AGENDA

Planning Committee Meeting to be held at Darebin Civic Centre, 350 High Street Preston on Monday 10 February 2025 at 6:30pm.

5.1 APPLICATION FOR PLANNING PERMIT D/377/2024

14 HOPETOUN AVENUE RESERVOIR

DRAWING TITLE GROUND FLOOR PLAN

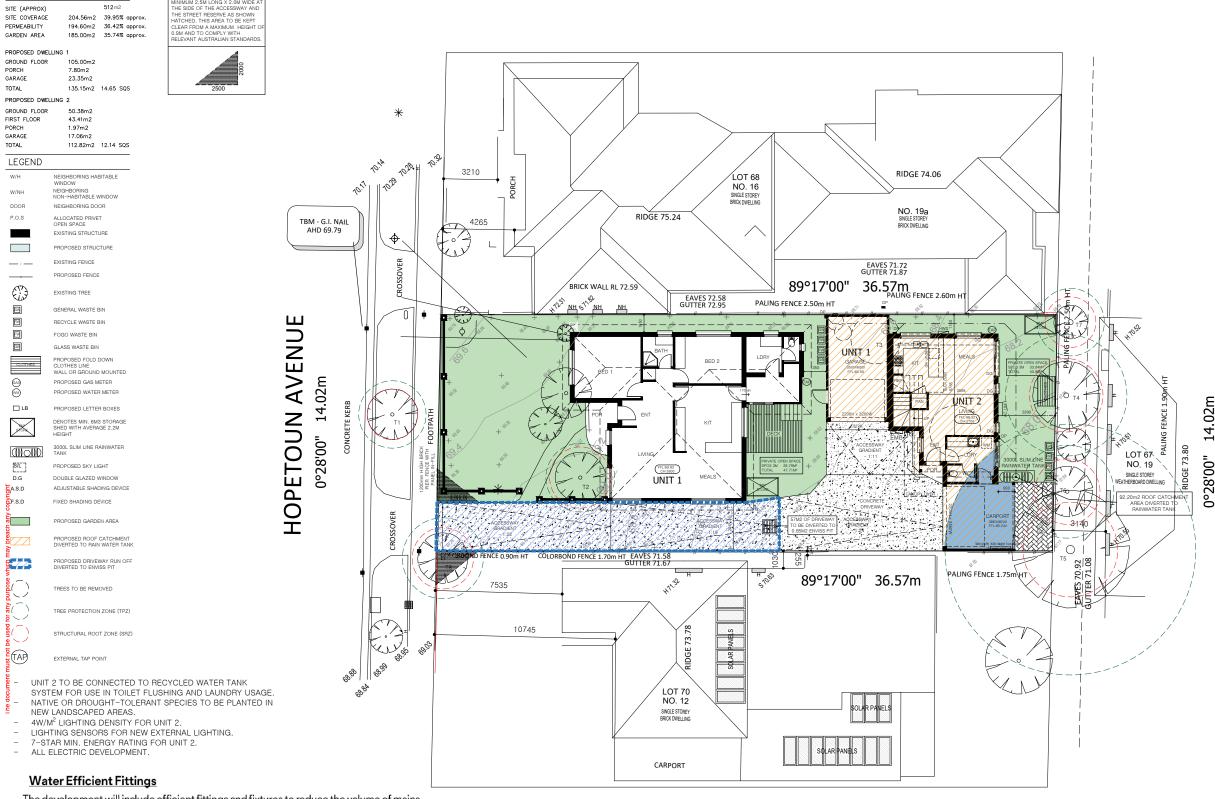
- (b) The sill height of the south facing bedroom 1 window of the proposed dwelling at least 1.7 metres above FFL, in accordance Standard B22.
 - (c) The sill height of the east facing bedroom 2 window of the proposed dwelling at least 1.7 metres above FFL, in accordance Standard B22.

- (g) The paving within the Tree Protection Zones (TPZ) of Tree #5 must be constructed above the existing grade using permeable materials to the satisfaction of the Responsible Authority. There must be no excavation within the TPZ, except for scraping the surface up to 30mm deep to remove surface organics and/or debris.

DRAWING TITLE ELEVATIONS

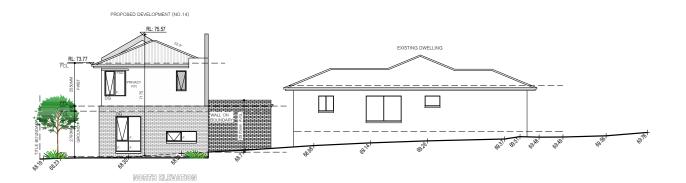
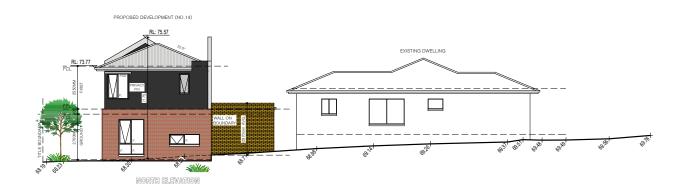
However, a condition is imposed to attain confirmation that the south and east facing bedroom windows to the proposed dwelling provide sill heights of at least 1.7 metres above FFL. in accordance with the Standard.
